Delegated Report

Planning Application No: 20250130

Location: Scouts Hall, Hampton Crescent Gravesend Kent

Description: Provision of a new modular-built scout and community facility to replace the existing building on-site, including associated landscaping and parking areas.

Block Plan - Existing, Originally Proposed & Revised

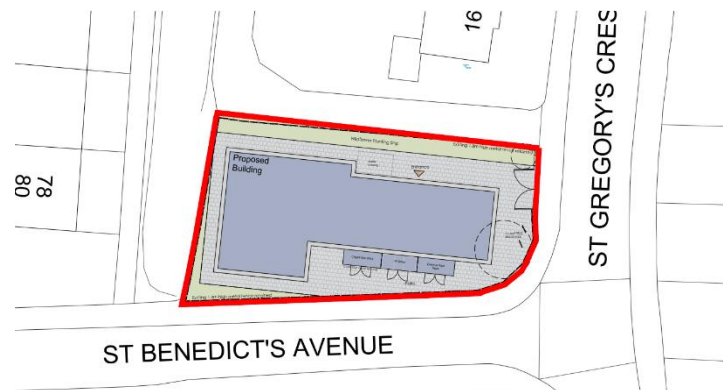
As originally submitted the proposed replacement building was considered unacceptable in design terms as it would have appeared as an incongruous feature in the street scene out of keeping with the character of the buildings in the area and therefore cause harm to the character and appearance of the street scene. This was due to:

- Large expanse of flat roof;
- Proposed materials – timber cladding does not weather well;
- Distinct lack of openings within the building creating a vast blank area;
- Unusual orientation of the building with the main entrance and therefore the principal elevation being located on the elevation adjacent to no. 168 Hampton Crescent;
- A more suitable location for the services is required – facing St Benedict's Avenue is not acceptable.
- Replacement building would be considerably larger than the existing one on site.

The agent was advised that the design of the building needed to be amended to address these matters including having a pitched roof, more openings, re-orientate the building so that it fronts Hampton Crescent or St Benedict's Avenue, re-locate the services from the St Benedict's Avenue façade so that they are more discreetly located and a reduction or reconfiguring of the footprint of the building.

The agent has submitted revised plans making some of the changes which were requested but not all. They advise that any changes need to be accommodated within the funding and modular delivery constraints of proposal. However, in response to the above issues the agent has made the following changes:

- The completely flat roof has been changed to a roof with a slight fall to it;
- The external timber cladding has confirmed to be Lunawood Thermowood – a

- durable and weather resistant material that naturally greys over time;
- There are a number of additional openings across the elevations;
- The main entrance has been relocated from facing no. 168 Hampton Crescent to facing St Benedict's Crescent;
- The external stores have been re-relocated to the rear away from the St Benedict's Avenue street frontage and therefore more discreetly sited. One of the external stores has been removed from the proposal;
- The overall size of building has been reduced slightly. The footprint of the building has been reduced by 4.9 sq. m. The width of the building has been reduced by 500mm – 1.4m and the height has been reduced by 0.48m at its highest point.

Elevations - Existing, Originally Proposed & Revised

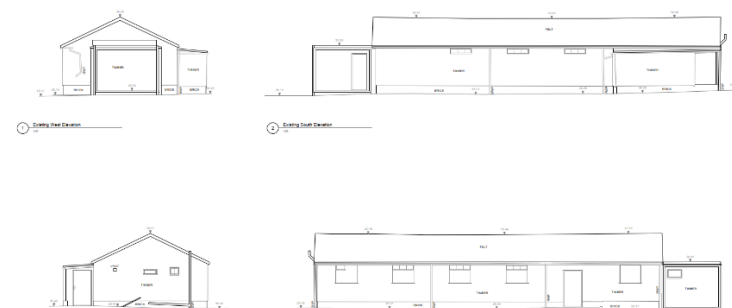
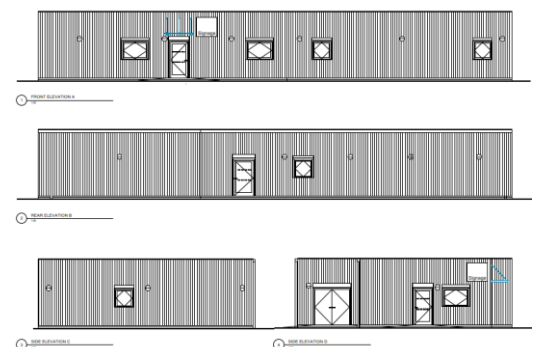
It is unfortunate that not all of the changes that were requested have been made. The existing building has a pitched roof and a pitched roof for the proposed replacement building would be much more in keeping than the flat roof proposed (with a slight fall). However, the agent has explained that the design changes that can be made are limited by the modular nature of the buildings. On balance it is considered that the proposed flat roof design can just about be supported given the building is single storey only, detached and of a modular design. The existing building is much smaller than what is proposed. Although it has been reduced in size from what was originally proposed, this is only by a fairly minimal amount. However, the building would be set in from each boundary of the site with areas of hardstanding around it with some planting to the southern boundary. Although much larger than the existing building in terms of footprint, the building would fit onto the site with space around it. The principal elevation and main entrance to the building being re-orientated so that it faces St Benedict's Crescent rather than the neighbouring property no. 168 Hampton Crescent is a great change in design terms as is the relocation of the external stores to the rear elevation rather than facing onto St Benedict's Crescent. The additional windows have reduced the large expanse of partly blank windowless elevations that were previously proposed. The change from timber effect rock panel fire resistant cladding for the walls to Thermowood fire resistant cladding is considered acceptable, it is said to weather to a grey colour.

Floor Plan – Existing, Originally Proposed & Revised

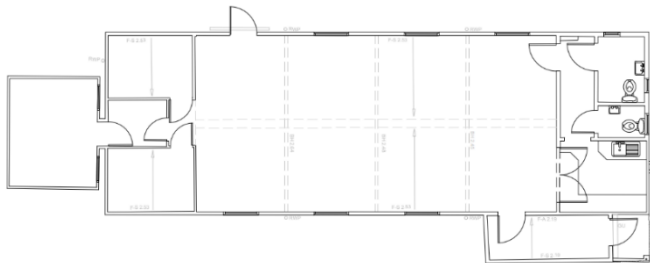
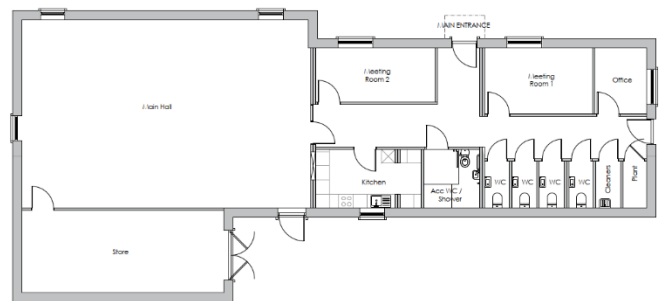
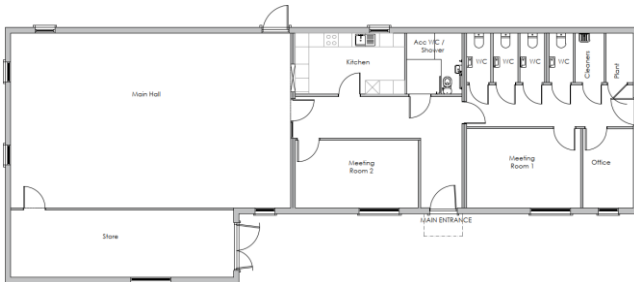
The matter of the proposed gas store and plant room was raised with the agent and further details requested. In respect of the proposed external caged gas store the agent was asked to confirm what gas would be stored within; they advised that it would be gas cylinders. GBC Environmental Protection have advised that they would expect the gas store to be external and have ventilation and that as this proposed external caged store has both these elements then it is acceptable.

In respect of the plant room, with the revised drawings for the amendments to the design of the building the plant room has been re-located from being an external attached plant room to one being located inside the building. The agent was asked for details of what the plant room would contain and also in terms of this being covered in the noise assessment to assess the impact of the plant equipment in respect of noise. The agent advised that there will be a distribution board, data cabinet and PV inverter board within the plant room which they consider is equipment that would not cause any noise related issues. GBC Environmental Protection have advised that the matter of the plant room can be dealt with by condition to request that prior to the operation of any plant/equipment, a noise impact assessment shall be carried out and submitted to the Local Planning Authority (LPA) demonstrating that the rating noise from fixed building services/mechanical plant/equipment,

including any air systems, associated with the development shall be at least 10dB below the existing LA90 background level at the nearest noise sensitive receptors (i.e. dwellings) when measured and assessed in accordance with BS4142:2014+A1:2019.
